August 28, 1992

Enclosed are the ABWR SSAR markups corresponding to the majority of the Piping Design Audit open items. The markups for the outstanding open items will be provided on the following schedule:

ABWR SSAR

AUDIT OPEN ITEMS

Figure 3.6-6 TYPICAL PIPE WHIP RESTRAINT CONFIGURATION

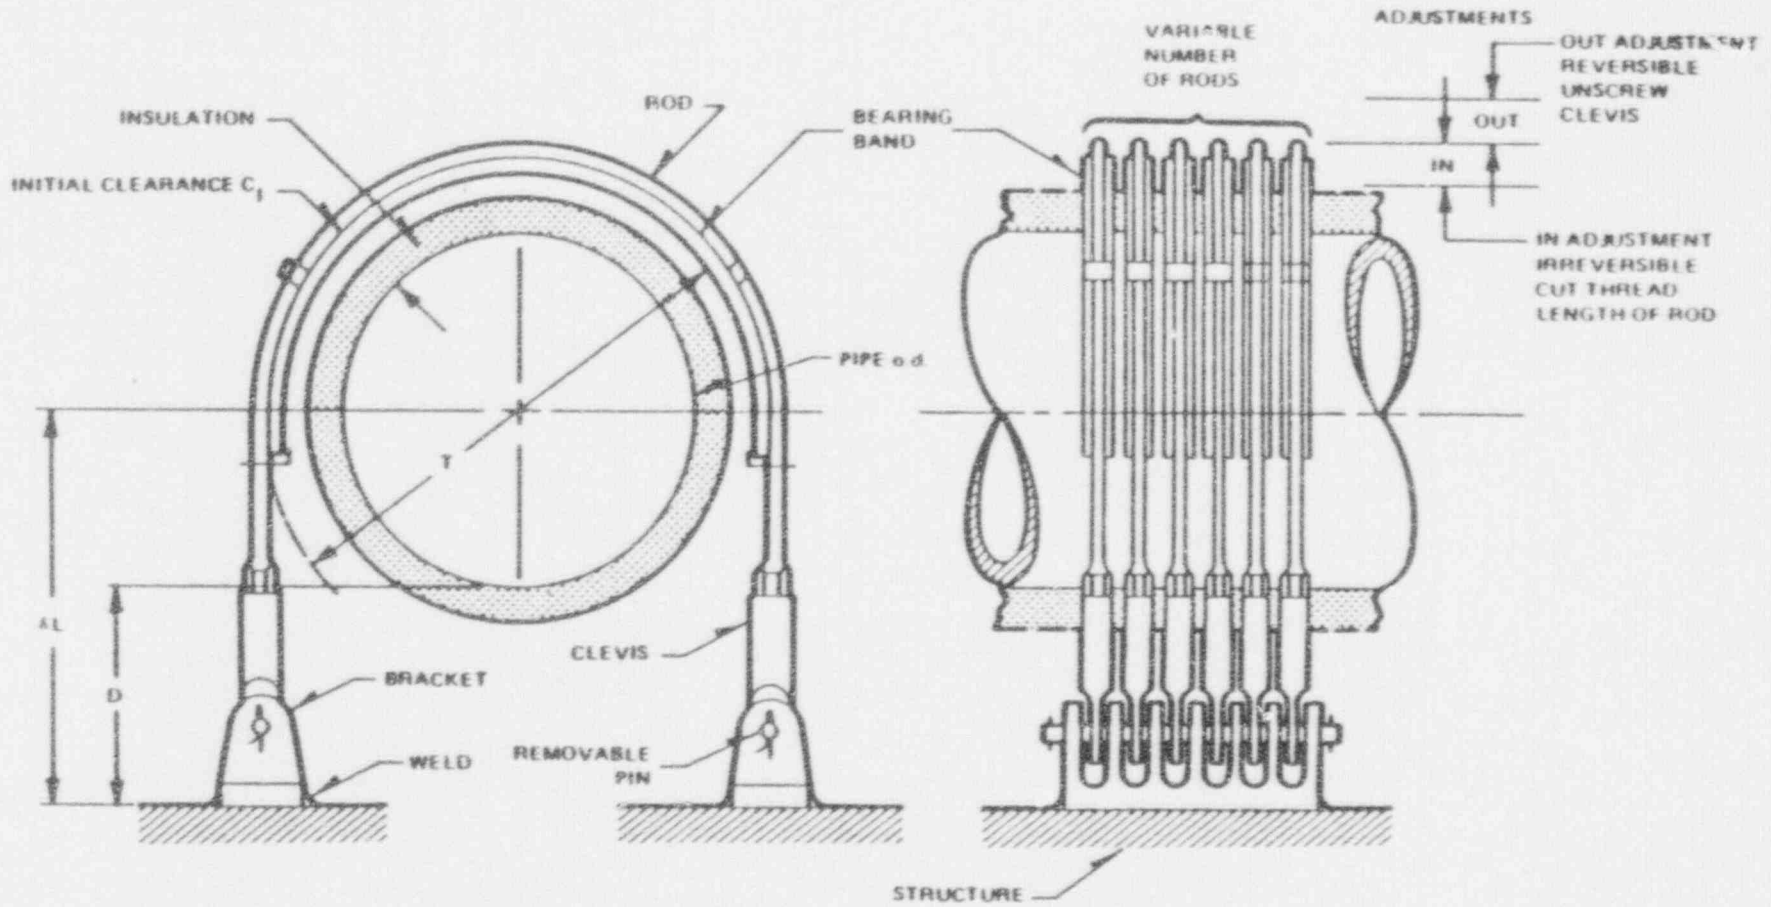
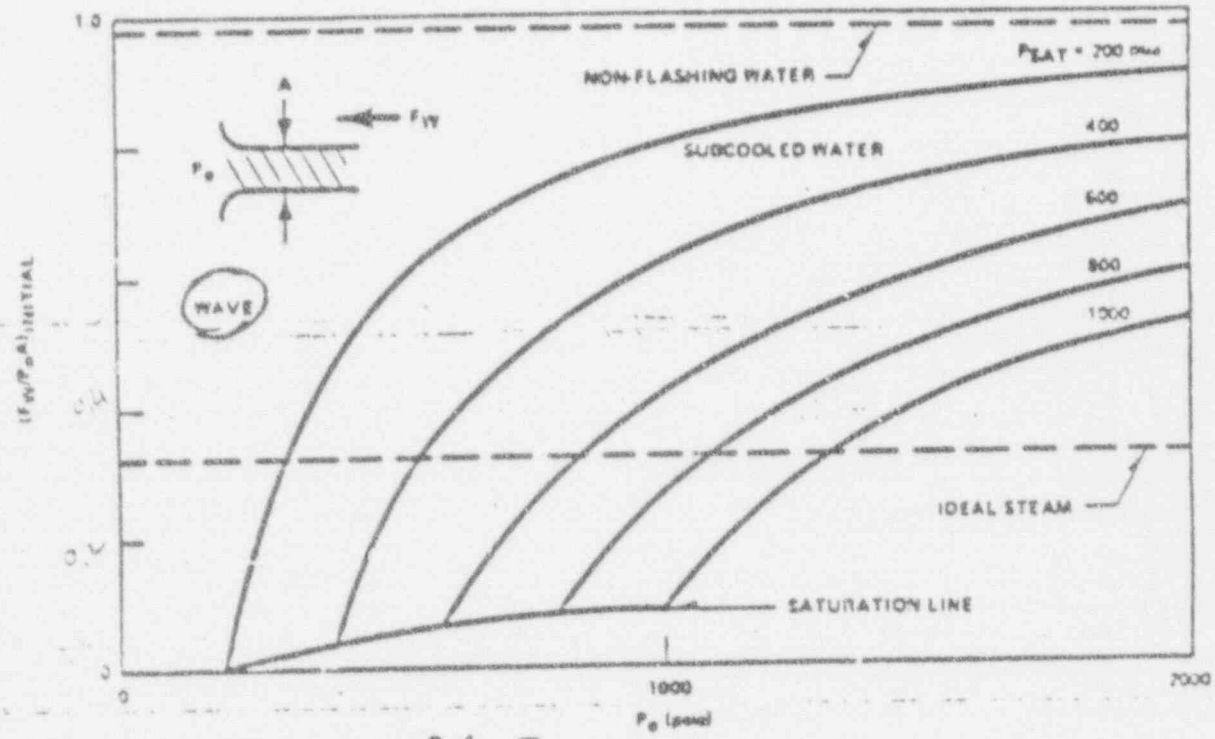
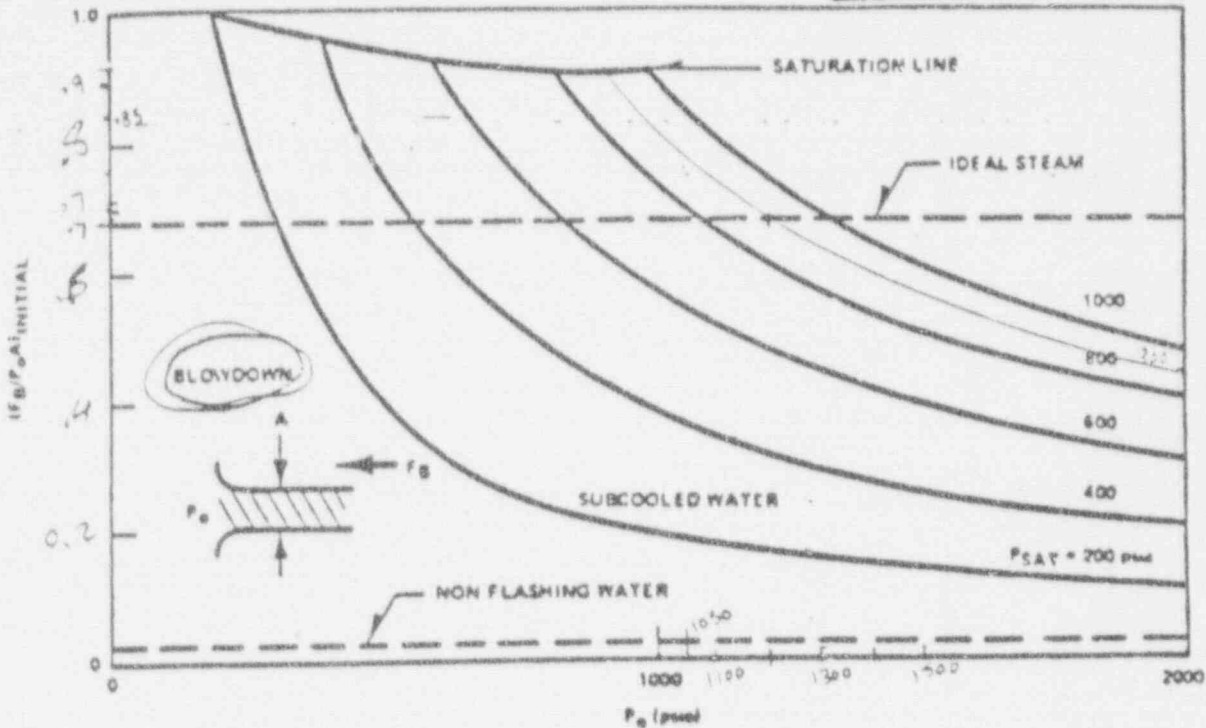
An analysis for pipewhip restraint selection PDA computer program; ~~and a pipe break modeling program~~ ~~ANBRS are performed as~~ described in Appendix 3D, which predicts the response of a pipe subjected to the thrust force occurring after a pipe break. The program treats the situation in terms of generic pipe break configuration which involves a straight, uniform pipe fixed at one end and subjected to a time-dependent thrust force at the other end. A typical restraint used to reduce the resulting deformation is also included at a location between the two ends. Nonlinear and time-independent stress-strain relationships are used to model the pipe and the restraint. Using a plastic-hinge concept, bending of the pipe is assumed to occur only at
